## SANTA FE CONSERVATION TRUST

### Memo

Re: SFCT proposal to build 180-ft. interim Acequia Trail on City Trail easement east of Henry Lynch Rd.

Date: Dec. 2, 2025

Figure 1: SFCT's Vision of Trail Connectivity in Henry Lynch Rd. area (as viewed on MPO Website)

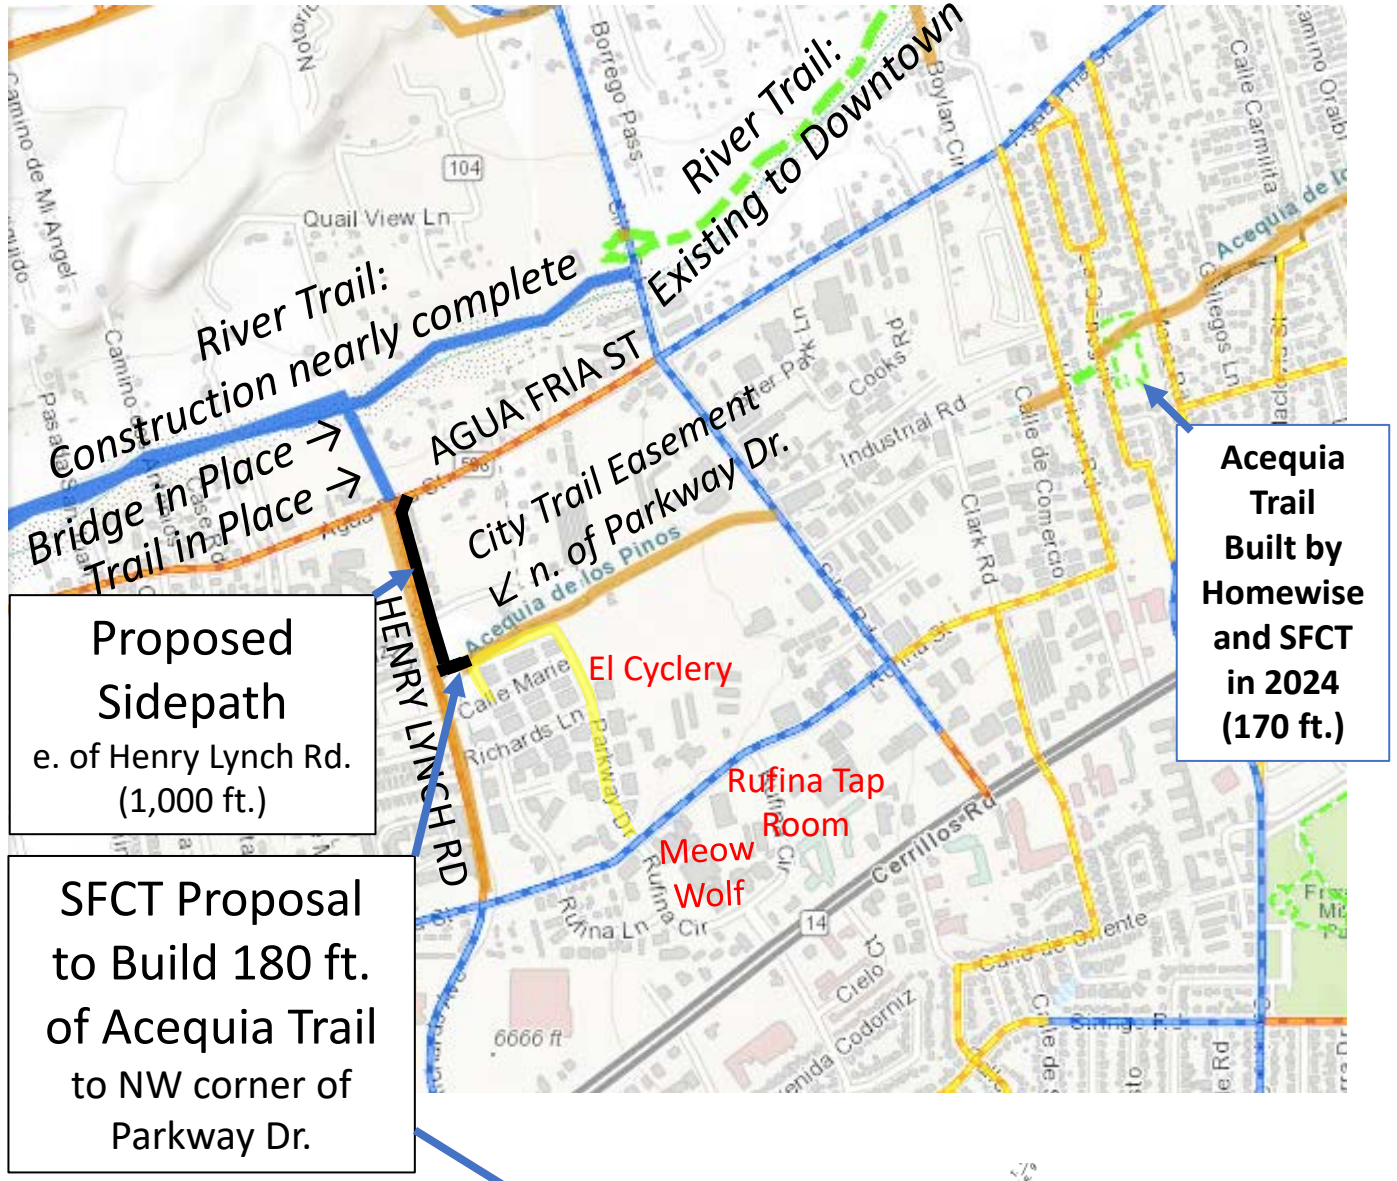
**I am urging the City and its Design Team to include the full ten-foot wide sidepath in Henry Lynch Rd. reconstruction plans for the following reasons. The Santa Fe Conservation Trust is willing to support and, with the help of trail volunteers, build the key 180 feet of Acequia Trail connecting Henry Lynch Rd. to Parkway Dr. that might be needed to help justify this decision.**

sidepath along Henry Lynch, is simply the **first 180 feet** of planned Acequia Trail from Henry Lynch Rd. to Parkway Dr., which would bring trail users to an extremely low-traffic and low-speed section of Parkway Dr. (in yellow on map) that is NOT a through route for cars – exactly like other safe and comfortable on-road extensions of the Acequia Trail elsewhere in Santa Fe.

**Proposed Sidepath**  
e. of Henry Lynch Rd.  
(1,000 ft.)

**SFCT Proposal to Build 180 ft. of Acequia Trail to NW corner of Parkway Dr.**

**Acequia Trail Built by Homewise and SFCT in 2024 (170 ft.)**

Figure 2: View of Acequia Trail Easement on Subdivision Plat

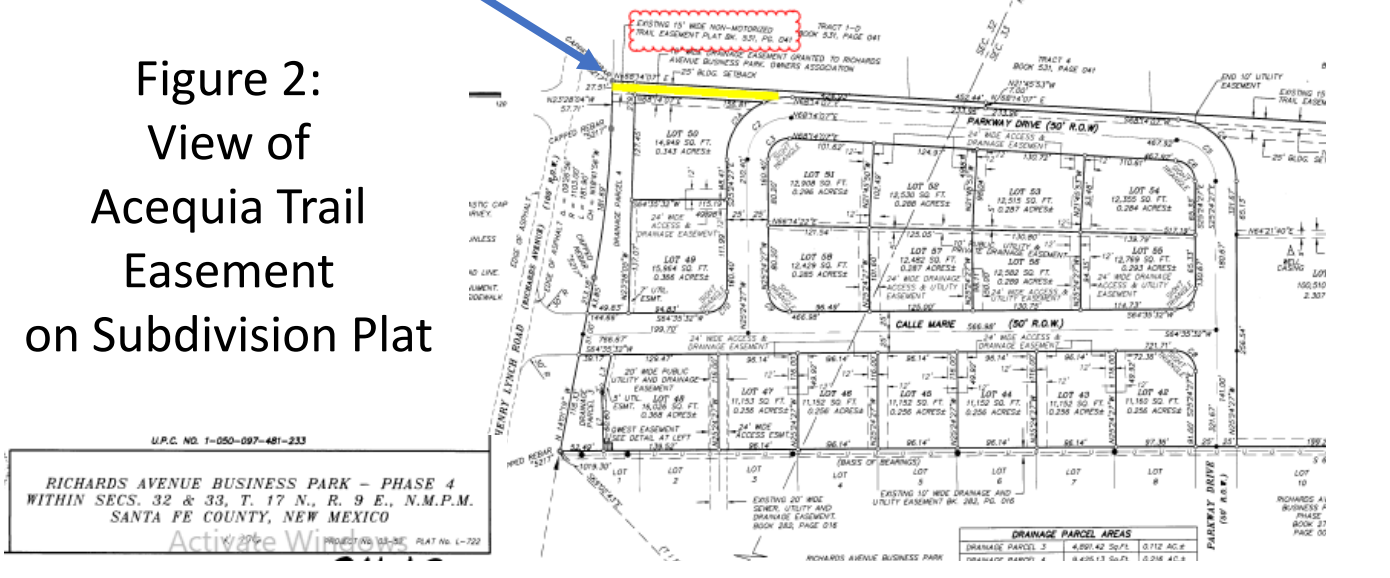
3. This stretch of Parkway Dr. features more than 1/10 mile (540 ft.) of sidewalk on its north side, just south of the Acequia Trail easement, that is uninterrupted by driveway crossings and thus can act as a continuous, safe and comfortable extension of the proposed Acequia Trail for trail users who wish to continue off-road.
